UNITED STATES
NUCLEAR REGULATORY COMMISSION
WASHINGTON, D. C. 20555

MEMORANDUM FOR: Edward L. Jordan, Chairman
Committee to Review Generic Requirements

FROM: Eric Beckjord, Director
Office of Nuclear Regulatory Research

SUBJECT: CRGR REVIEW OF PROPOSED RESOLUTION OF
GENERIC SAFETY ISSUE B-56, "DIESEL
RELIABILITY"

Figure 1, Reliability Monitoring & Maintenance Activities

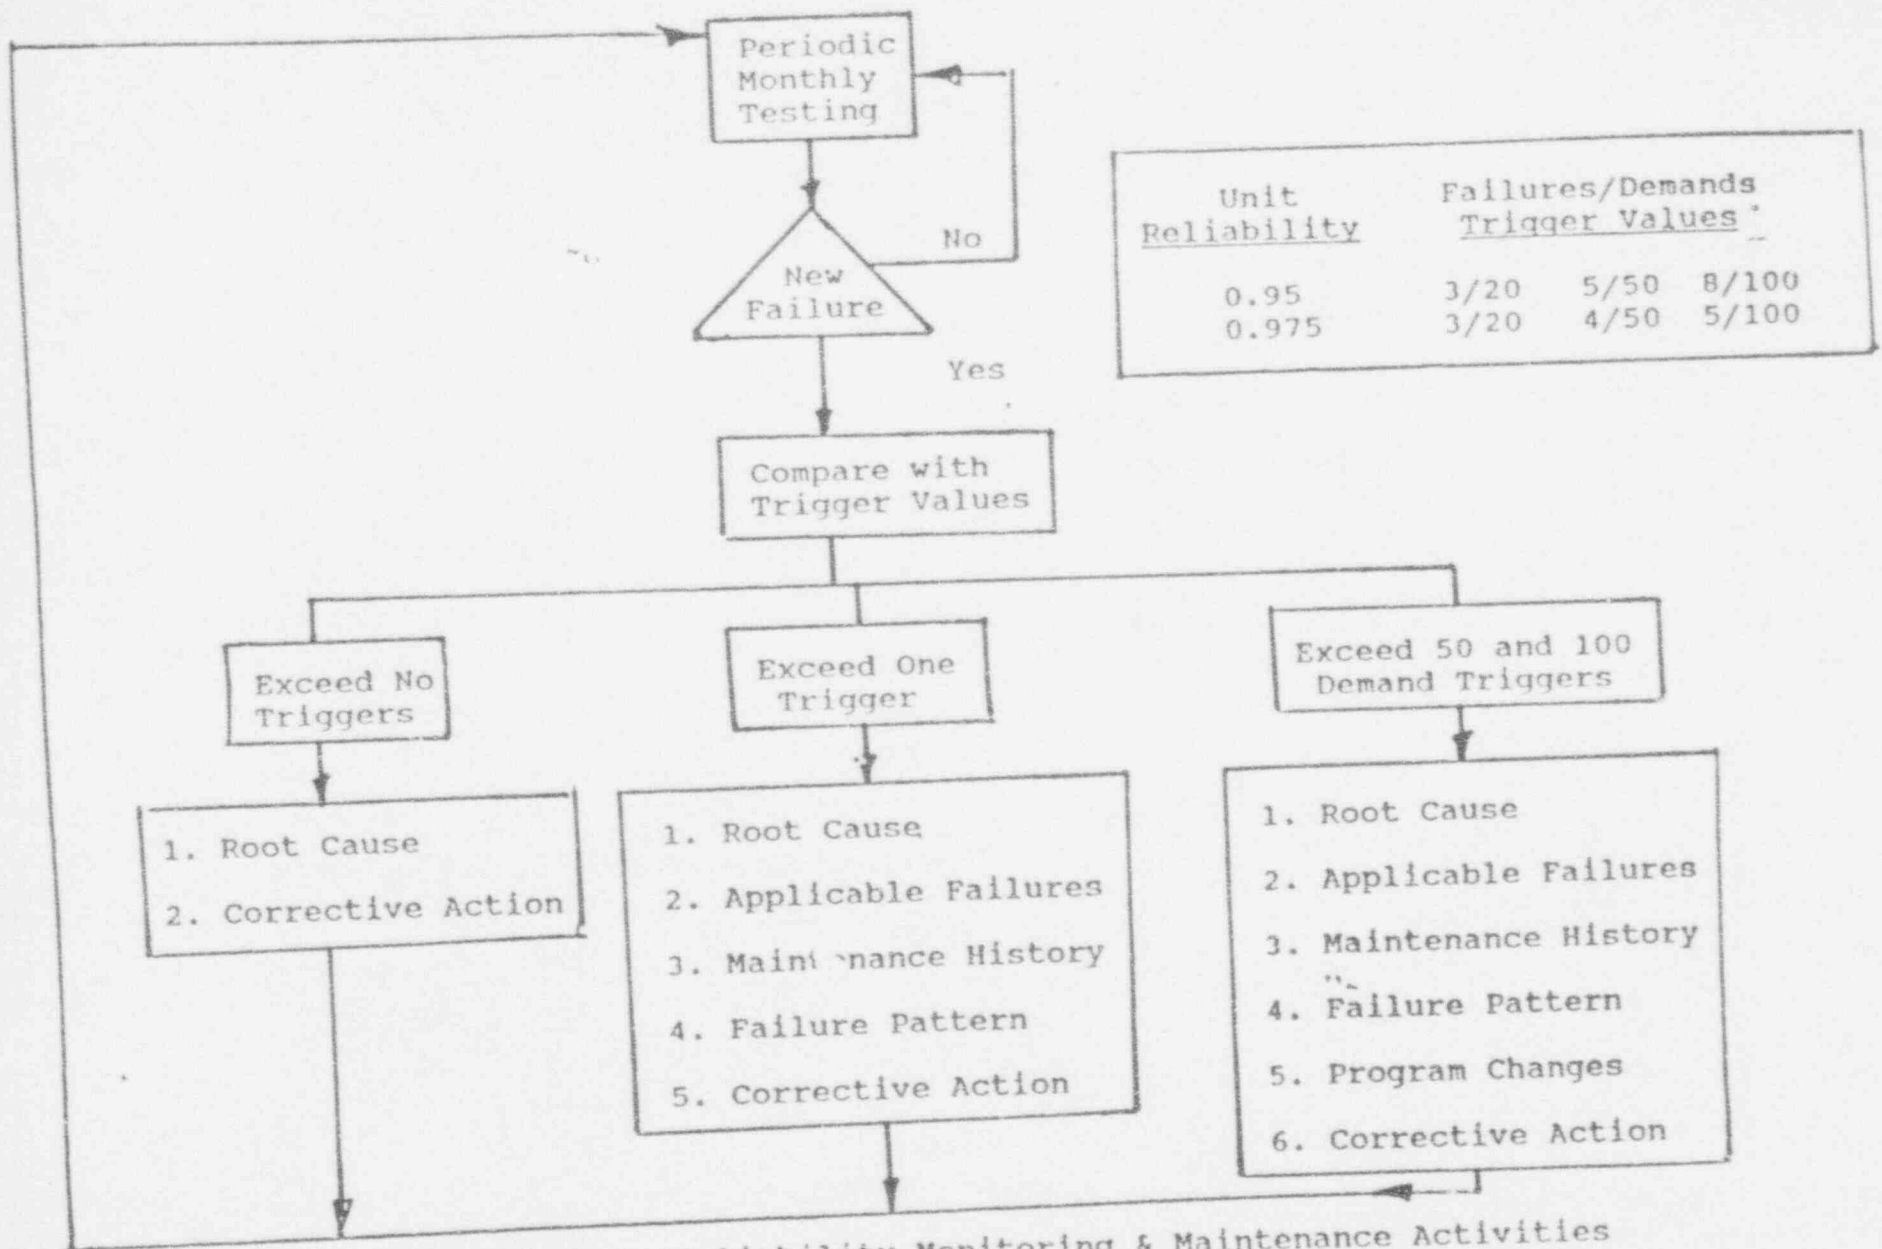
Figure 1 -- This can be deleted as it duplicates what is in the revision to NUMARC 87-00 Appendix D that has been issued to utilities.
